Code Technology Committee

Area of Study – Climbable Guards

2007/2008 Cycle

Code changes related to the CTC area of study noted above

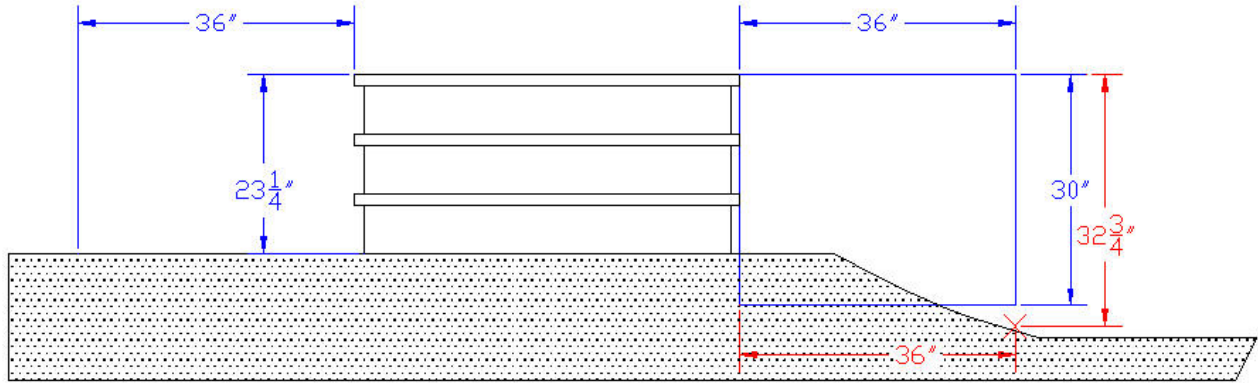
Reason: To provide fixed points for measuring the 30 inch vertical riser height of elevated surfaces to determine if guards are required.

1. The existing R312.1 states that guards are required when the walking surface is 30 inches or more above the walking surface below, however it does not define clearly where to measure that vertical measurement. This proposed code change also sets a set of parameters as to where to take the measurements.

The diagram below was drawn by the author and is shown as a visual guide or technical drawing. The drawing shows a 3 riser front entry stoop with 7-3/4" risers from a front elevation. The ground is detailed in outlined dots. The 36" horizontal with 30" vertical box on the right shows the area in which the code change submits the measurements should be taken. The 32-3/4" vertical point shows the deepest point within the 36" horizontal edge measurement. The left side of the stoop is shown not over 30" in height and thus no guard required.

Thus if this stoop was on a facility it would require a guard be installed on the right side only as the left side is not 30 inches or more deep.

1013.1 (IFC [B] 1013.1) (Supp) Where required. Guards shall be located along open-sided walking surfaces, mezzanines, equipment platforms, stairways, ramps and landings that are located more than 30 inches (762 mm) above the floor or grade below measured vertically to the floor or grade below at any point within 36 inches (914 mm) horizontal to the edge of the open side. Guards shall be adequate in strength and attachment in accordance with Section 1607.7. Where glass is used to provide a guard or as a portion of the guard system, the guard shall also comply with Section 2407. Guards shall also be located along glazed sides of stairways, ramps and landings that are located more than 30 inches (762 mm) above the floor or grade below where the glazing provided does not meet the strength and attachment requirements in Section 1607.7.

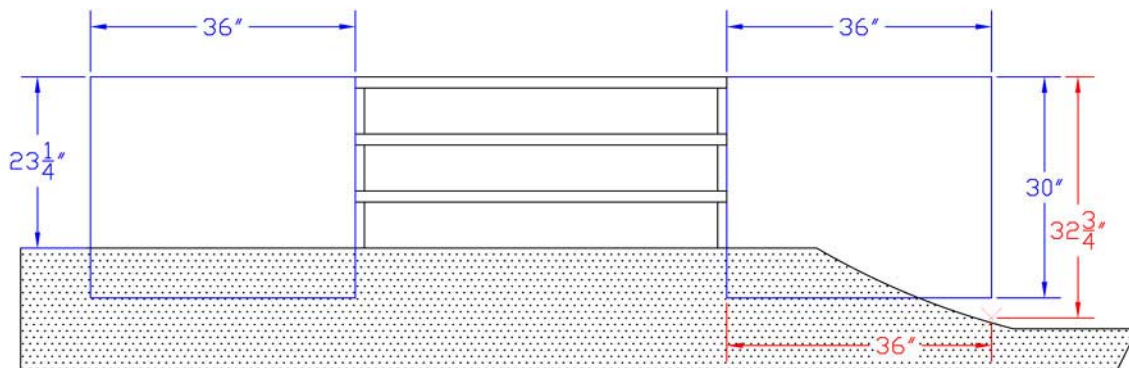
The key part of this change to IBC 1013.1 is submitted in order to clarify how the height measurement which triggers the guard requirement is made relative to proximity to the adjacent fall-off. This is illustrated in the following figure:

The view is taken from the landing of a 3 riser stair, looking towards the face of the risers.

1013.1 (IFC [B] 1013.1) (Supp) Where required. Guards shall be located along open-sided walking surfaces, including mezzanines, equipment platforms, stairways, stairs, ramps and landings, that are located more than 30 inches measured vertically to the floor or grade below at any point within 36 inches (914 mm) horizontally to the edge of the open side above the floor or grade below. Guards shall be adequate in strength and attachment in accordance with Section 1607.7. ~~Where glass is used to provide a guard or as a portion of the guard system, the guard shall also comply with Section 2407. Guards shall also be located along glazed sides of stairways, ramps and landings that are located more than 30 inches (762 mm) above the floor or grade below where the glazing provided does not meet the strength and attachment requirements in Section 1607.7.~~

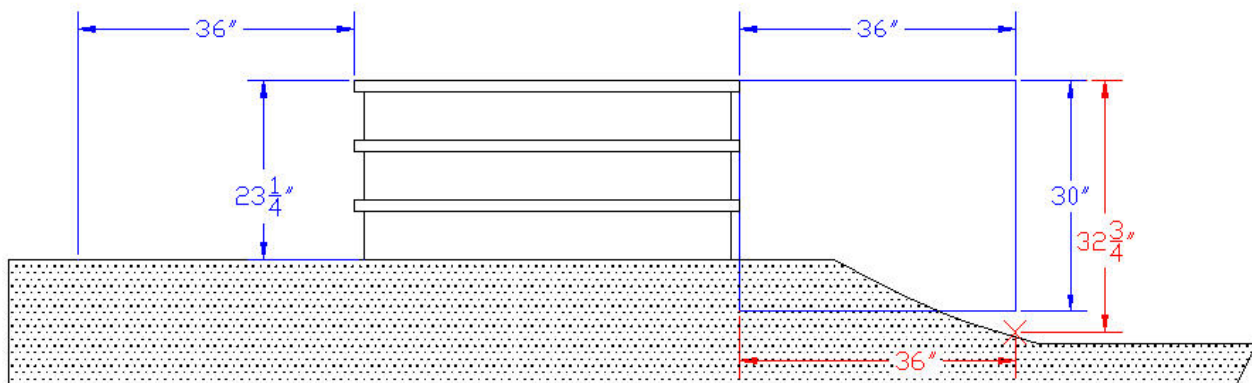
Reason: The purpose of the proposal is to create consistency between IRC 312 & IBC 1013 and next to provide fixed points for measuring the 30 inch vertical riser height of elevated surfaces to determine when guards are required.

2. The existing R312.1 states that guards are required when the walking surface is 30 inches or more above the walking surface below, however it does not define clearly were to measure that vertical measurement. This proposed code change also sets a set of parameters as to where to take the measurements.

The diagram below was drawn by the author and is shown as a visual guide or technical drawing. The drawing shows a 3 riser front entry stoop with 7-3/4" risers from a front elevation. The ground is detailed in outlined dots. The 36" horizontal with 30" vertical box on the right shows the area in which the code change submits the measurements should be taken. The 32-3/4" vertical point shows the deepest point within the 36" horizontal edge measurement. The left side of the stoop is shown not over 30" in height and thus no guard required.

Thus if this stoop was on a home it would require a guard be installed on the right side only as the left side is not 30 inches or more deep.

R312.1 (Supp) Where Guards required. ~~Guards shall be provided on all decks, landings, porches, balconies, ramps or raised floor surfaces located more than 30 inches (762 mm) above the floor or grade below. Required guards shall not be less than 36 inches (914 mm) in height. Open sides of stairs with a total rise of more than 30 inches (762 mm) above the floor or grade below shall have guards not less than 34 inches (864 mm) in height measured vertically from the nosing of the treads.~~ Guards shall be located along open-sided walking surfaces, including porches, decks, balconies, mezzanines, stairs, ramps and landings, which are located more than 30 inches (762mm) measured vertically to the floor or grade below at any point within 36 inches (914 mm) horizontally to the edge of the open side. Insect screening shall not be considered as a guard.

R312.2 Height. Required guards at open-sided walking surfaces, including stairs, porches, balconies or landings, shall not be less than 36 inches (914mm) high measured vertically above the above the adjacent walking surface or the line connecting the leading edges of the treads.
